Access Compliance Report Public Rights-of-Way (Curb Ramps)

Main Street: WALLINGSFORD_RD	Cross Street: HARRISBURG_RD	Location: NE
------------------------------	-----------------------------	--------------

ADA ID: RPRK211215115808	Ramp Type: Type 1 - Perpendicular Diagonal Initial Pass/Fail: Pass	Overall Compliance: No	Severity Score: 12
--------------------------	--	------------------------	--------------------

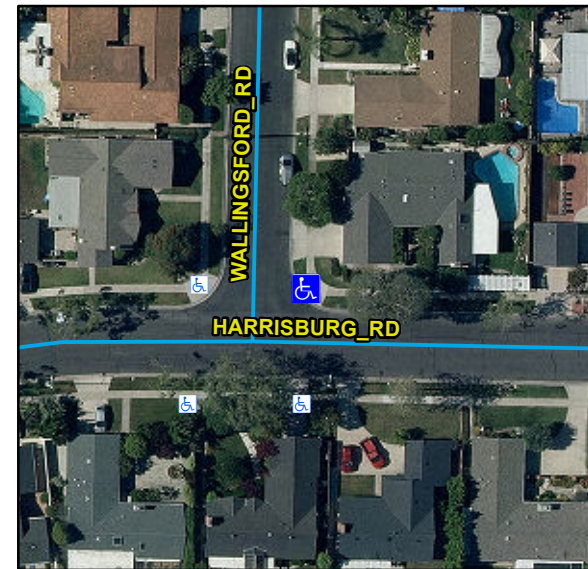
N/A	Ramp Inside Crosswalk 1	N/A	Yes	Ramp Inside Crosswalk 2	N/A
	Crossing 1 Slope (%)	2.7		Crossing 2 Slope (%)	7.3
	Crossing 1 Cross Slope (%)	0.7		Crossing 2 Cross Slope (%)	1.2
No	Gutter Ponding	Yes	No	Curb Slope	9.6
Yes	Gutter Lip Height (in)	0		Road Run Slope (%)	0.1
Yes	Gutter Run Slope (%)	3.4		Road Cross Slope (%)	3.8
Yes	Gutter Cross Slope (%)	0.5			
Yes	Overall Surface Condition: Acceptable		No	Perp Joint Present	No
	Cross Gutter Present?	No		Spandrel Present?	No
	Replace Cross Gutter?	N/A		Replace Spandrel?	N/A

Possible Solutions:
Remove & Replace Curb Ramp With Two New Directional Ramps or Equivalent.
Surveyor Notes:
N/A
OC Std/PROW:
R304.2.2, R204.3, R304.2.2-Perp, R304.3.2-Para, R305, R302.7, STD 1115
Total Cost:
\$ 6160
